FINAL
ENVIRONMENTAL IMPACT STATEMENT

**F-15E BEDDOWN AT SEYMOUR JOHNSON AFB,
NORTH CAROLINA**

November 18, 1988

- (a) Responsible Agency: United States Air Force
- (b) Proposed Action: Conversion of F-4 to F-15E aircraft that will be equipped with the new Low Altitude Navigation and Targeting Infrared for Night (LANTIRN) system at Seymour Johnson AFB, Wayne County, North Carolina.

MILITARY TRAINING ROUTE MAPS

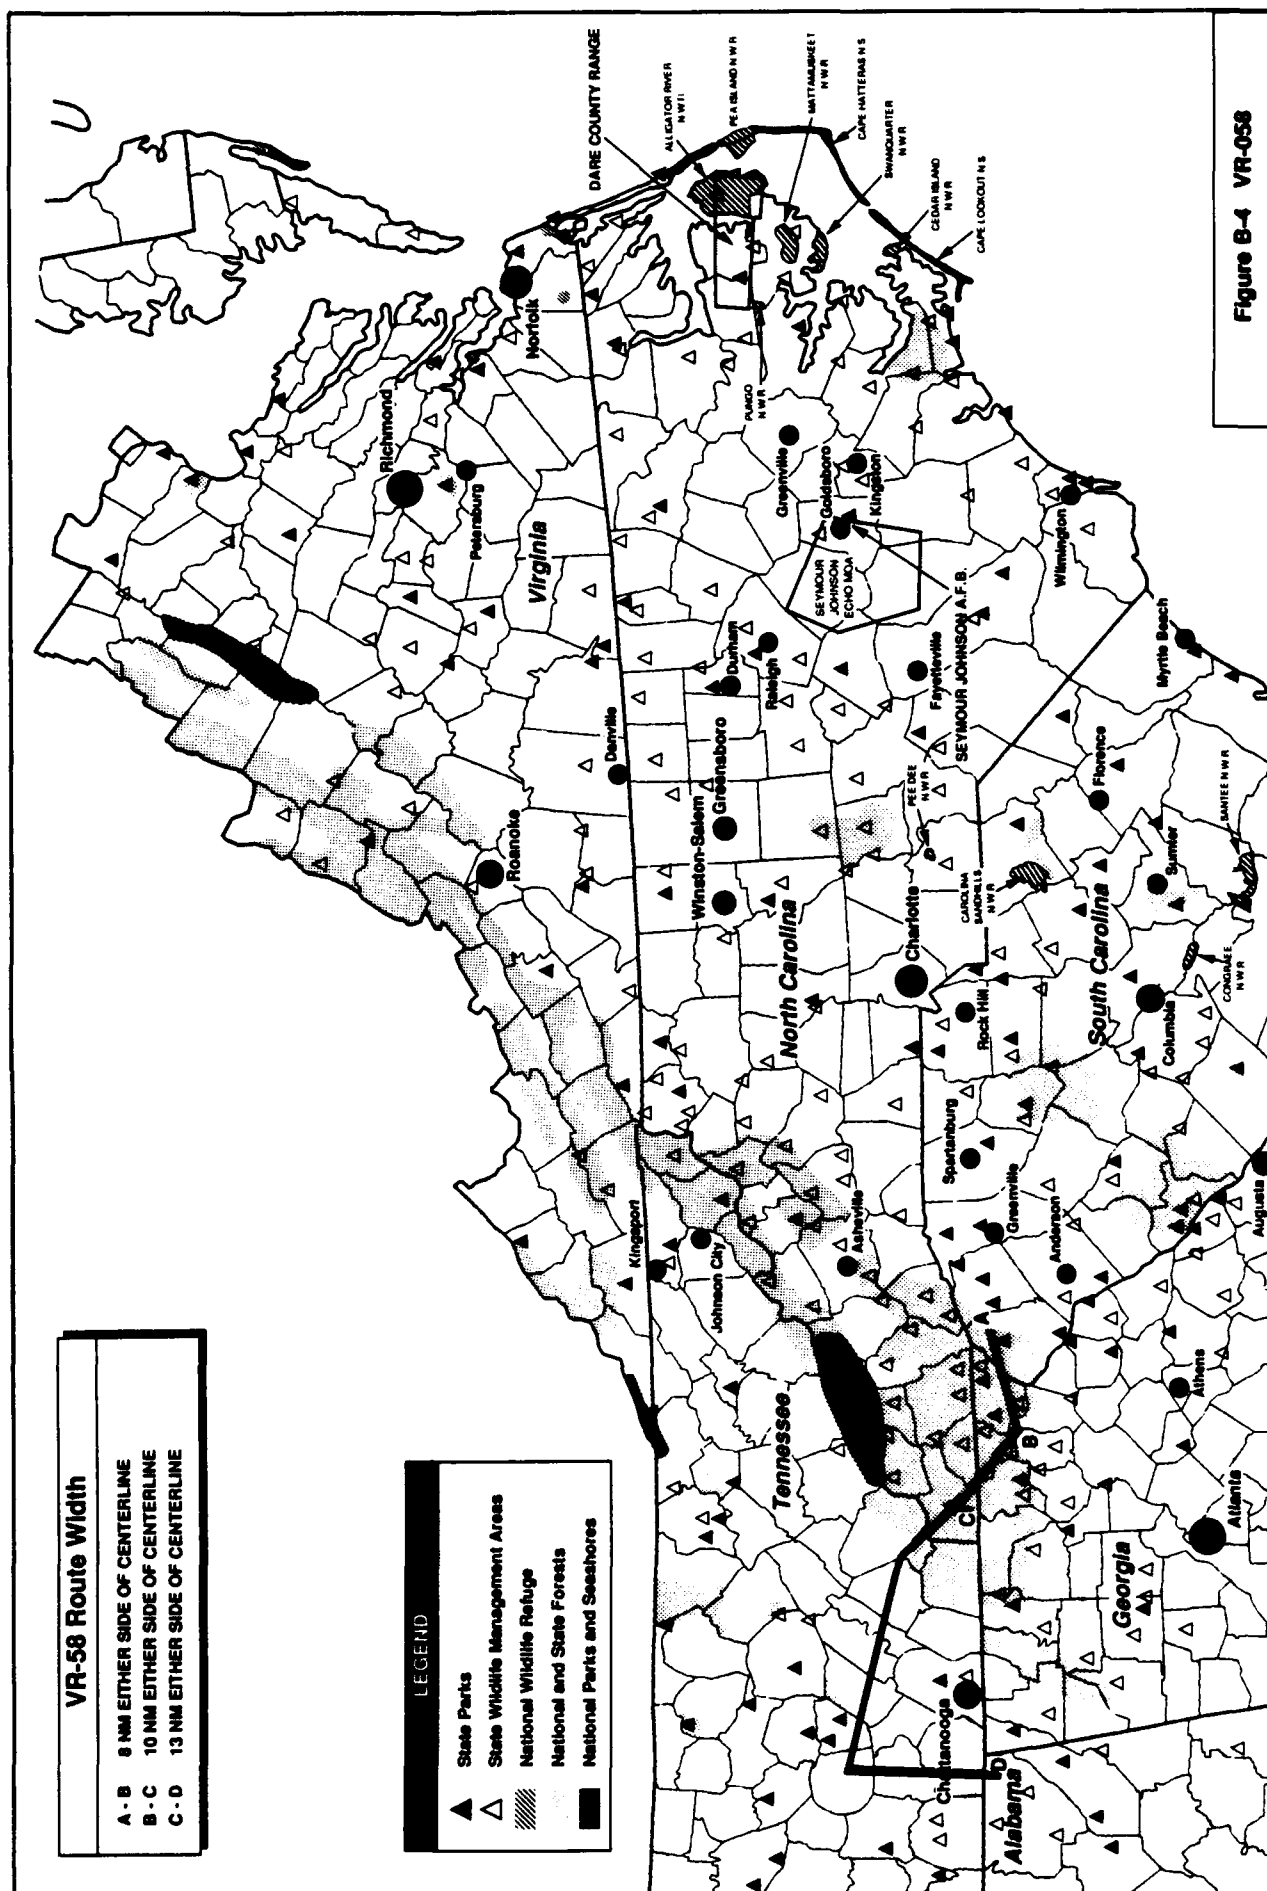
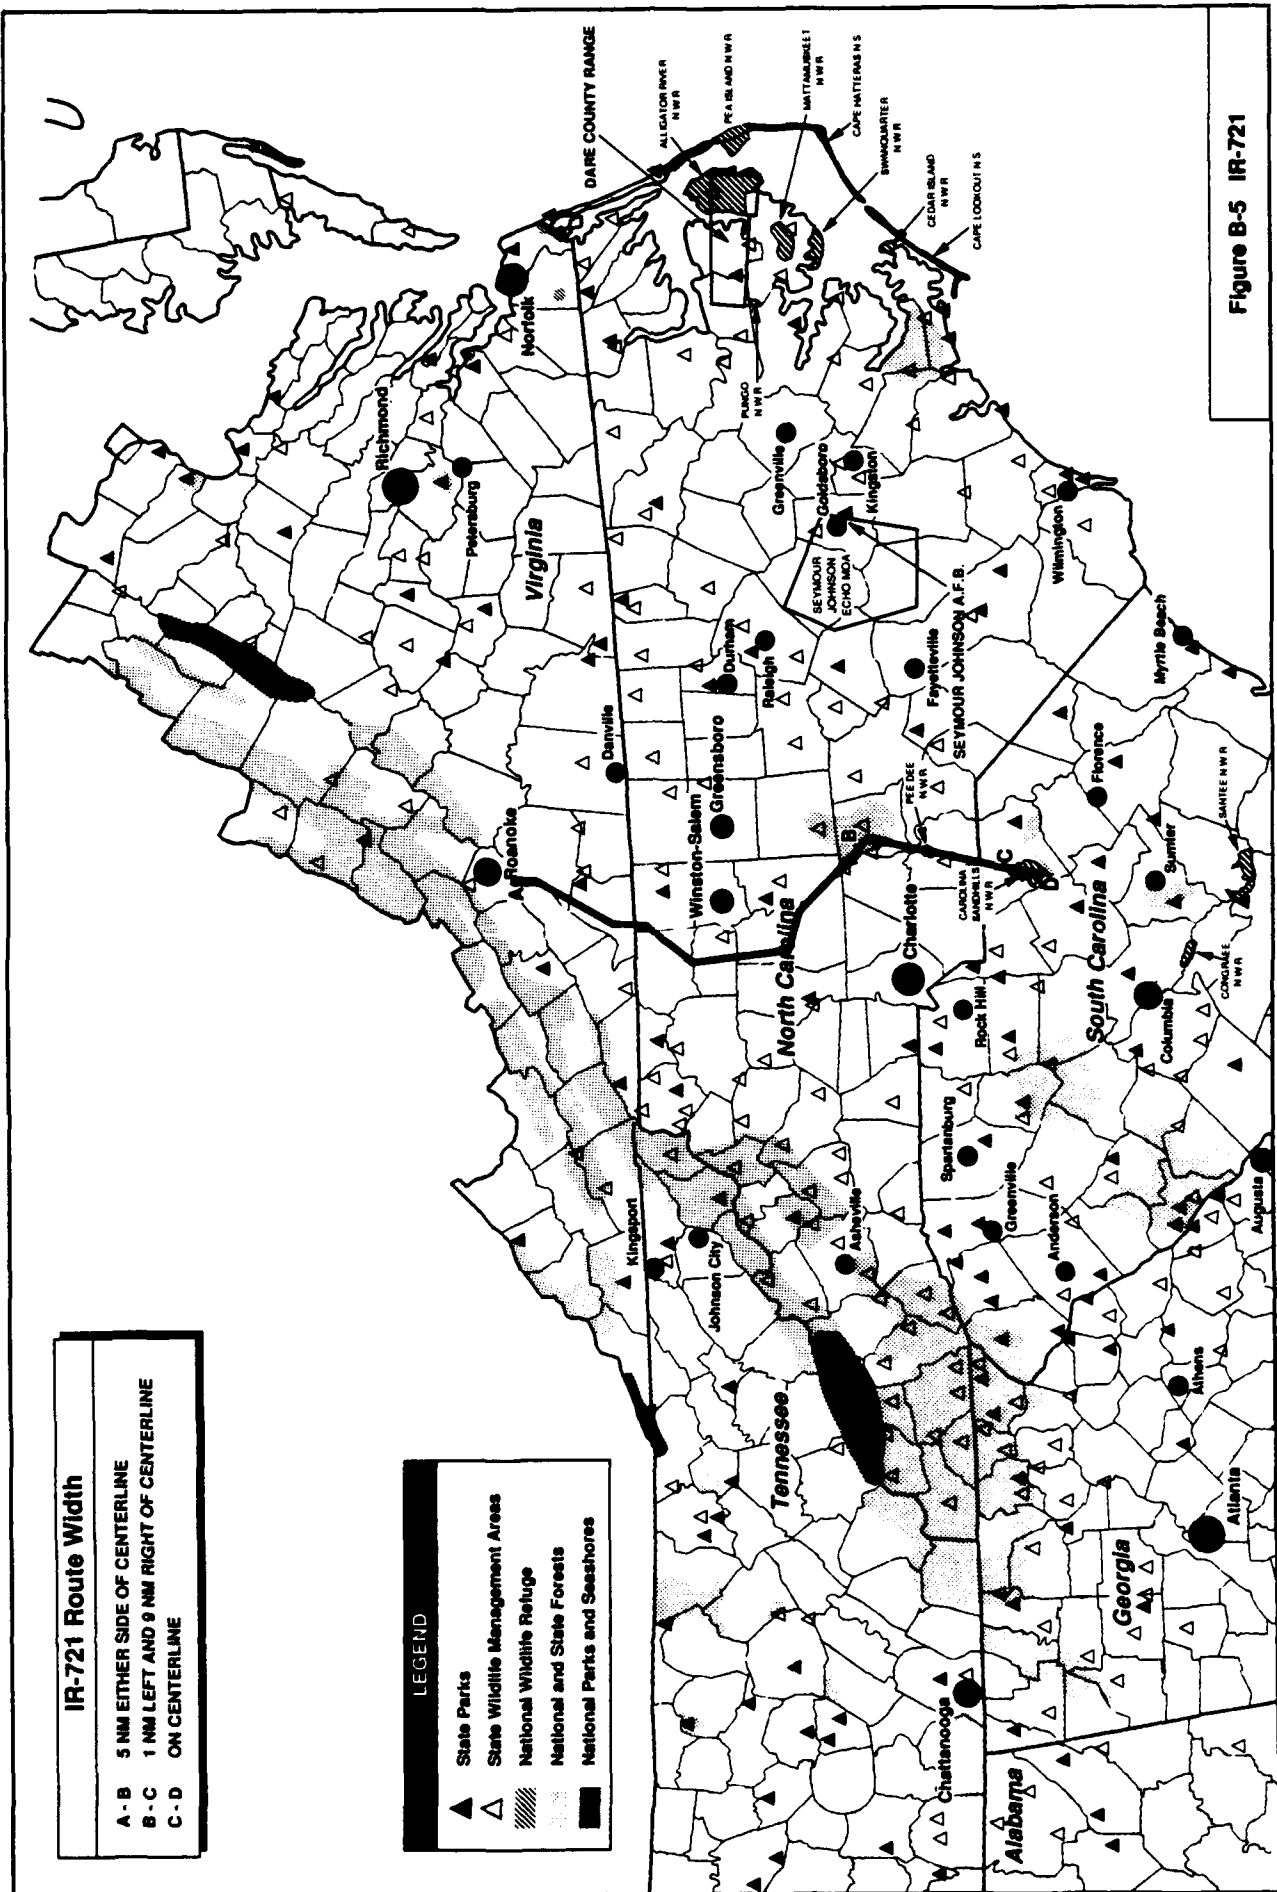
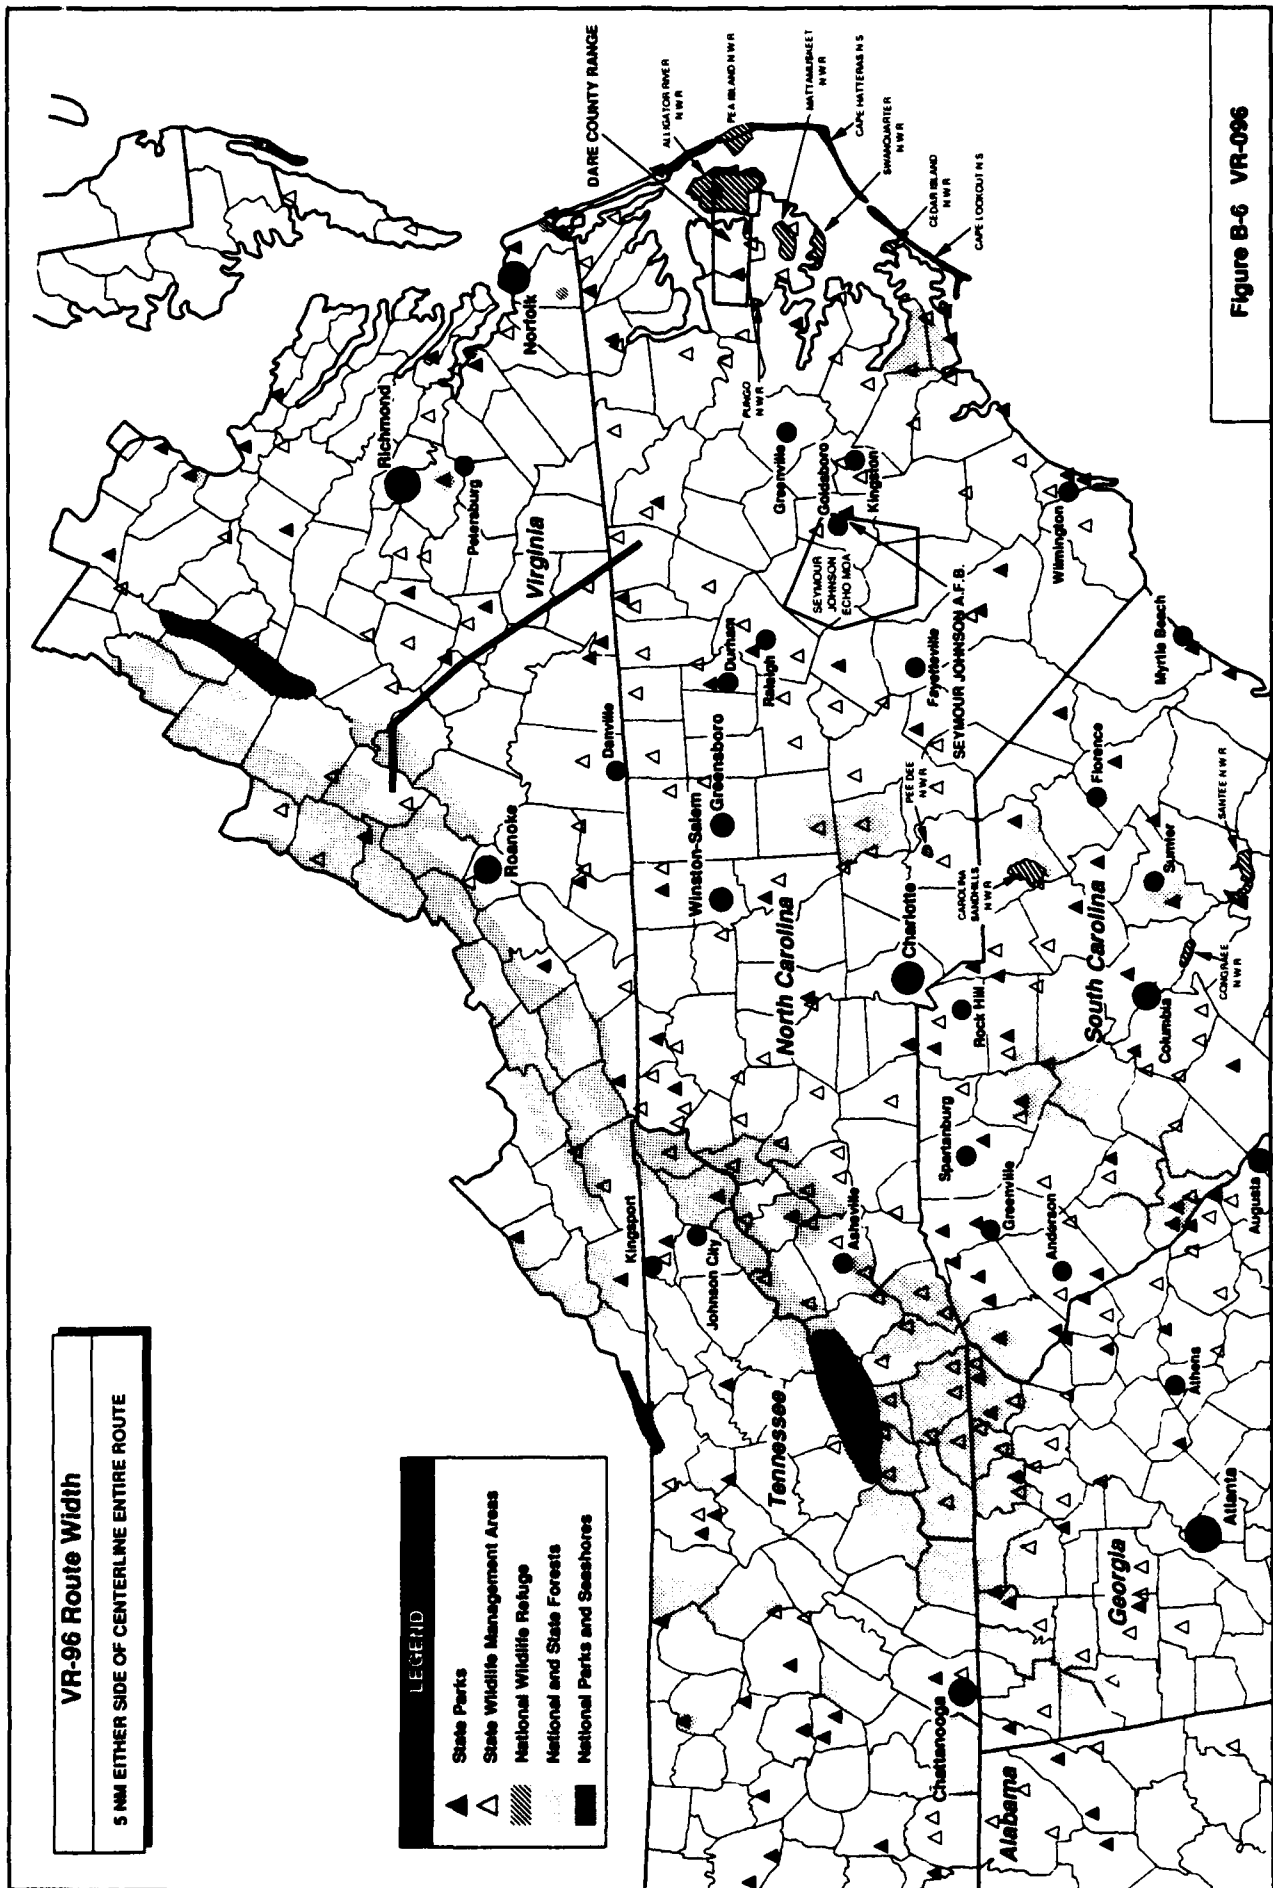
Page 3.0-3. Figure 3.0-2 only qualifies as a general representation of the MTR proposed for use and is not sufficient

to show their relationship with other facilities. For instance, neither R-5301 and 5302 nor R-5313, or Pamlico MOA are on the map. It is impossible to identify the location of any site in the interior of the state if it is not on the map.

77. The correct reference is to Figure 3.0-2. See errata (Chapter 5). Additional information on the location of "wildlife management and recreation areas" is provided in Appendix B.

13. p. 2.4-2, Table 2.4-1, Impact Area, No Action Alternative, and Proposed Action columns: Insert "Fire Potential", 0, and 0, respectively.
14. p. 3.0-3, Figure 3.0-2, VR-096 and VR-1043. Routes were drawn beyond legs specified in AP1B extracts for MTRs. See revised maps in Appendix B.
